Annex 5

Working Group on Explosives (23 – 26 June 2014)

Changes for Section 18 of the Manual of Tests and Criteria (5th Revised Edition)

Section 18 – amend Section 18 as indicated below

Figure 18.4.1.1: DEWAR VESSEL WITH CLOSURE

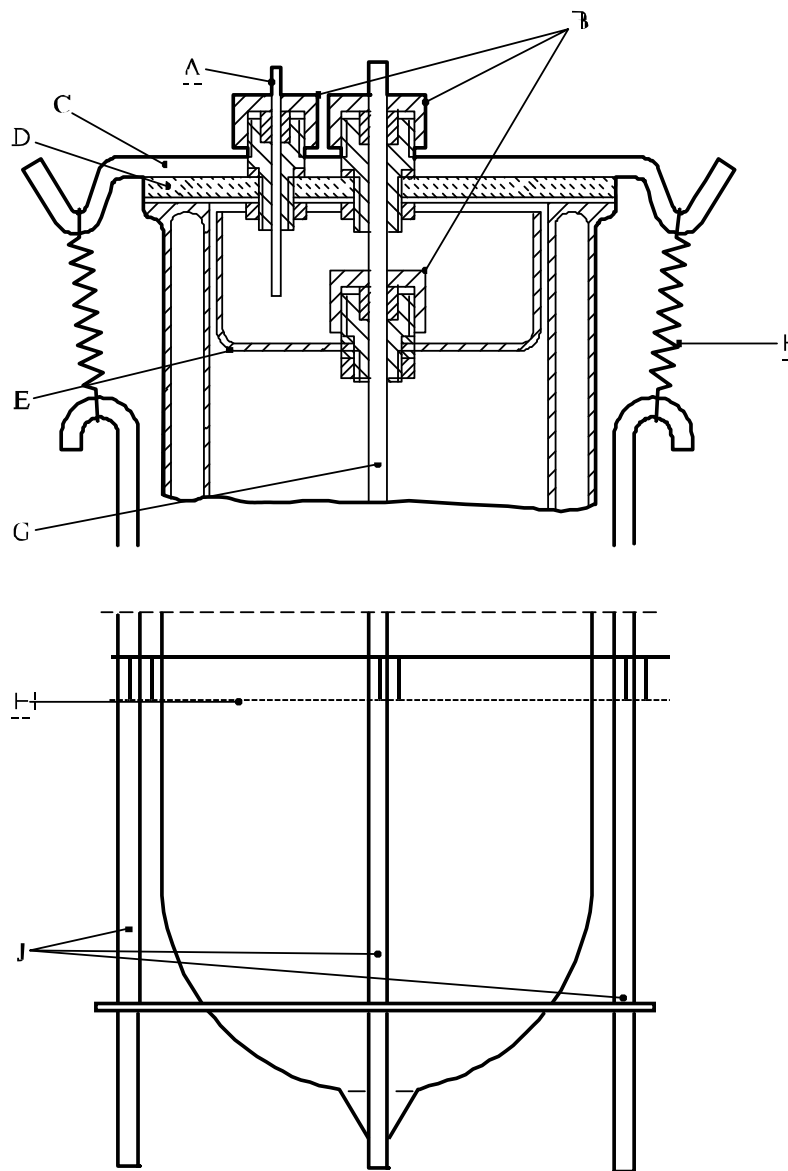
18.4.1.2.4 ~~Dewar~~Insulated test vessels with a volume of ~~approximately 500 m~~500 ml with a closure system are used. The closure of the ~~Dewar~~test vessel should be inert. ~~A closure system is illustrated in Figure 18.4.1.1.~~

Figure 18.5.1.1: ANE GAP TEST

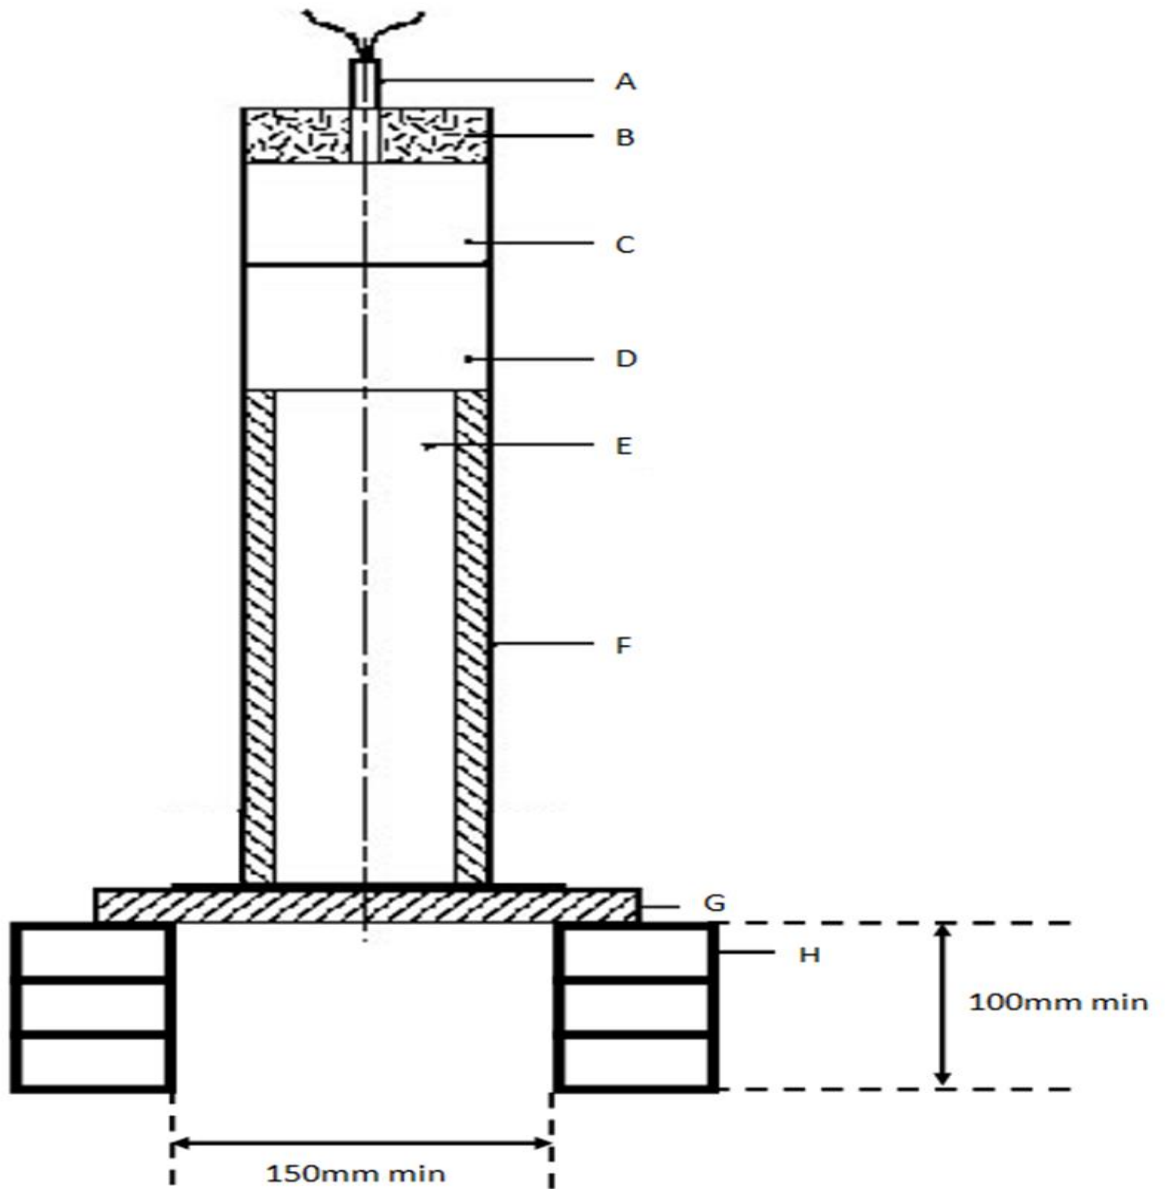
18.5.1.2.1 The set-up for this test consists of an explosive charge (~~donor~~booster charge), a barrier (gap), a container holding the ~~test charge~~sample substance (acceptor charge), and a steel witness plate (target).

18.5.1.3.1 As shown in Figure 18.5.1.1, the detonator, ~~donor~~booster charge, PMMA gap and acceptor charge are coaxially aligned above the centre of the witness plate. The bottom end of the tube is sealed with a single layer of cloth adhesive tape, or equivalent, to contain the sample substance which is carefully loaded so as to avoid the formation of voids within the sample or between the sample and the tube walls. The surface of the sample should be level with the rim of the tube. Care should be taken to ensure good contact between the detonator, ~~the booster charge, and donor, donor and gap and the PMMA cylinder gap and the acceptor charge.~~ The test sample and booster should be at ambient temperature for the test. The sample substance should be at ambient temperature. The wood block holding the detonator, the booster charge, the PMMA cylinder and the steel tube should be held firmly in alignment (e.g. by using a band of adhesive tape at each intersection).

Figure 18.6.1.1: TEST TUBE ASSEMBLY

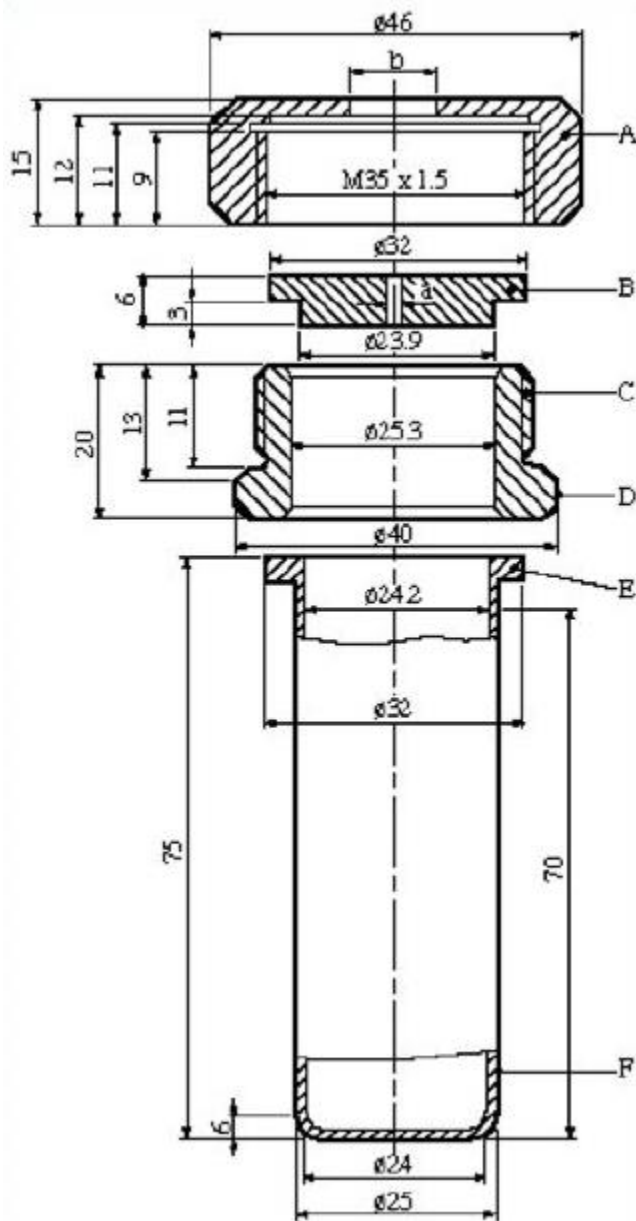
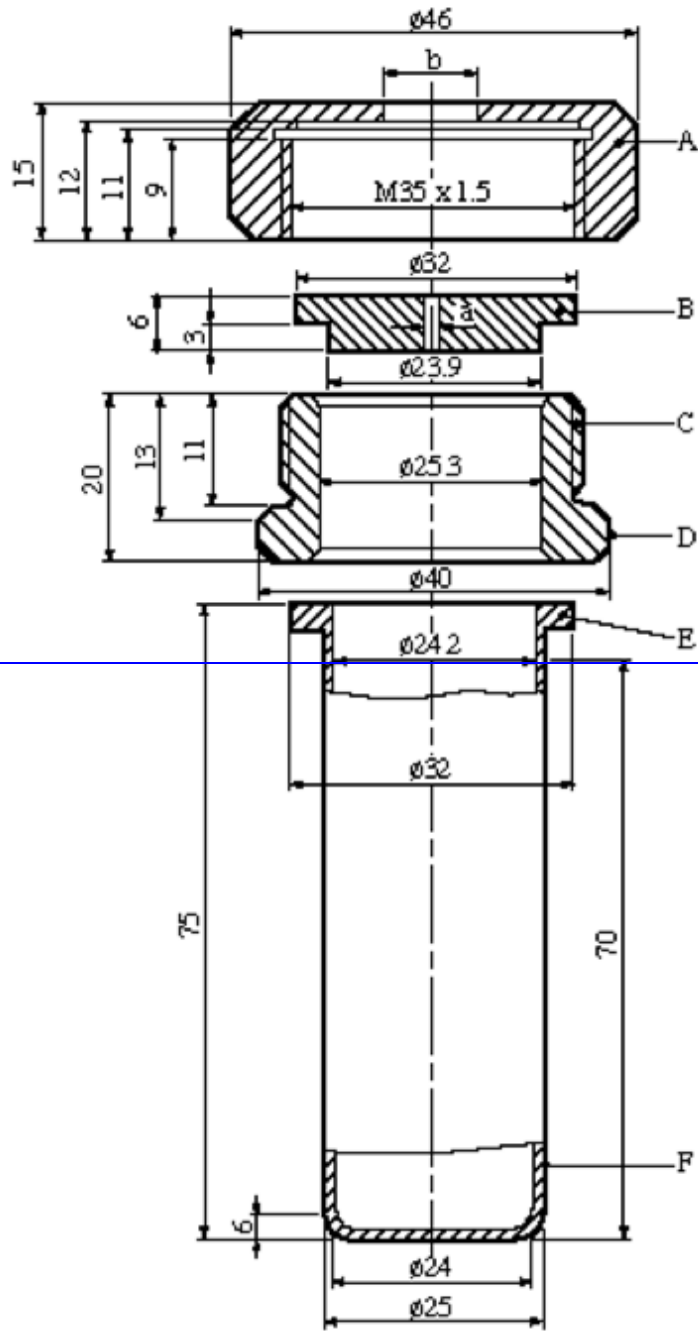
- 1.5 mm for the closing plate used in the heating calibration procedure; and
- 2.0 mm for the closing plate used in the test.

~~3.1~~ ~~5.0 8.0 12.0 20.0 mm~~. The dimensions of the threaded collar and the nut (closing device) are given in Figure 18.6.1.1.

Figure 18.7.1.1: VENTED PIPE TEST

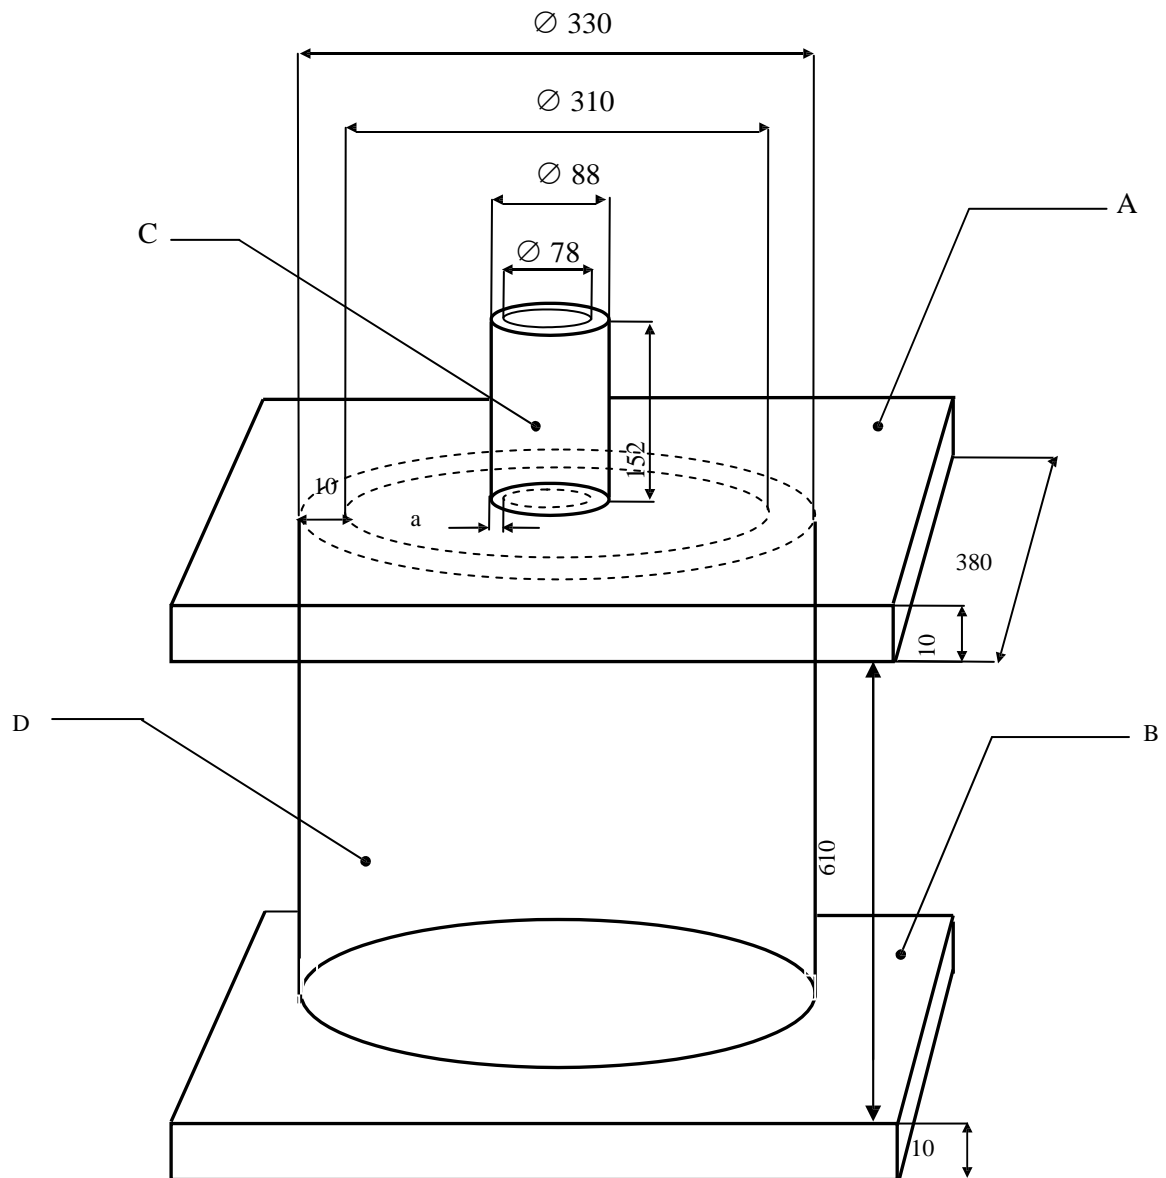
- (a) A steel pipe 310 ± 10 mm diameter and 610 ± 10 mm long, welded close at the bottom with a 380 mm square, 10 ± 0.5 mm thick mild steel plate. The top of the pipe is welded to a 380 mm square, 10 ± 0.5 mm thick mild steel plate that contains a 78 mm diameter vent hole centrally located in the plate to which a 152 mm long steel pipe nipple of 78 mm internal diameter is welded (see Figure 18.7.1.1). All welding should be to a relevant ISO standard or equivalent. All steel components are to be Schedule 40 carbon steel (A53 Grade B) or equivalent;
